2011 Fish Passage Plan Change Form

Change Request Number: 11LWG001_Navigation Spill Operations

Date: October 22, 2010

Proposed Change:

Attachment 1: Lower Granite Lock and Dam

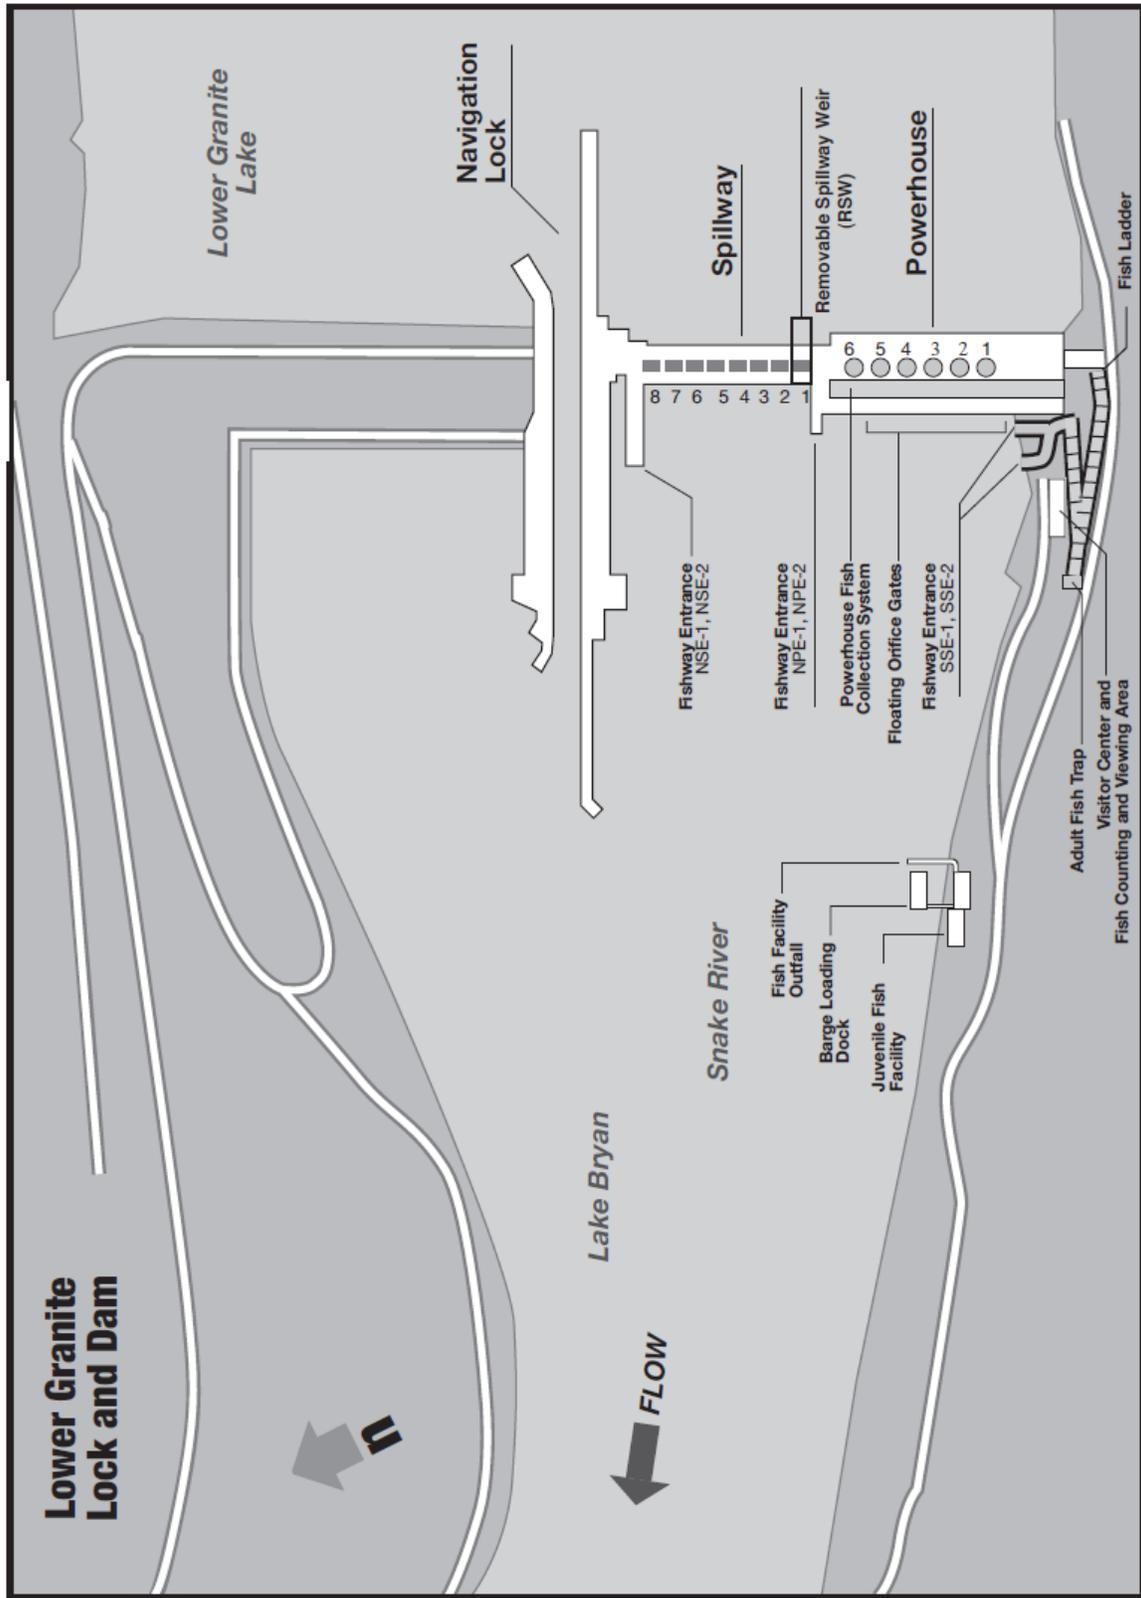
The Corps would like to prevent navigation guide wall collisions in 2011. In 2010 a fish barge collided with the navigation guide wall (Attachment 1). Navigators also expressed navigation safety concerns at Lower Granite in 2006 (Attachment 2). The Corps presented the navigation safety concern to TMT (Attachment 3) and FPOM resulting from the collisions that occurred in 2010 (Attachment 4). In coordination with the region the Corps developed and implemented a modified spill operation (temporarily shutting off spillway weir and spilling in a uniform pattern) to provide safe navigation conditions in the LWG tailrace. No additional collisions with the guide wall occurred after the Corps implemented the modified spill operation for navigation safety. To avoid collisions in the future the Corps would like to include the modified spill operation implemented in 2010 in the FPP. This change form updates the existing fish barge navigation discussion by adding additional details to clarify operations associated with navigation.

Figure 2. Lower Granite Incident Diagram.

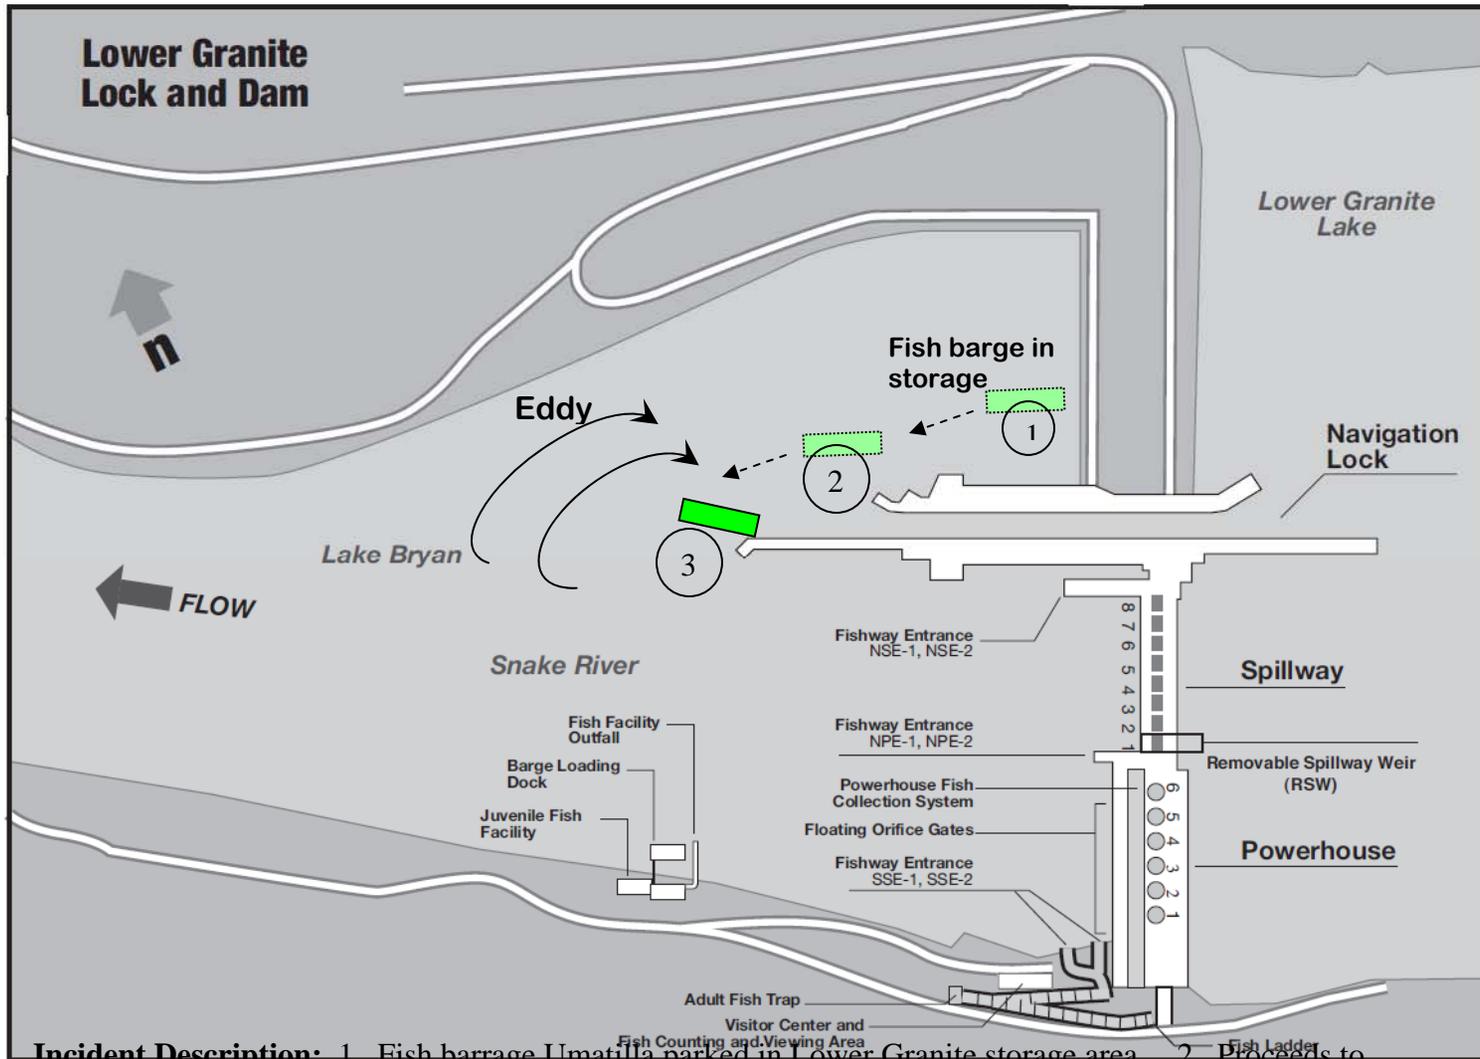
1. Umatilla 8106 fish barge backing out of storage area at Lower Granite collided with guide wall when rounding corner tip of wall (See Figure 2 on page 5). Note that incident details were compiled from dam operator, awaiting official incident report.
2. Cruise vessel possibly entering upper navigation lock and struck guide wall. Details will be finalized after official incident report is completed.
3. No known difficulties.

Incident Description: 1. Fish barge Umatilla parked in Lower Granite storage area. 2. Proceeds to back out of storage area and maneuver to juvenile fish facility on south shore. 3. Eddy current forces starboard side bow into guide wall
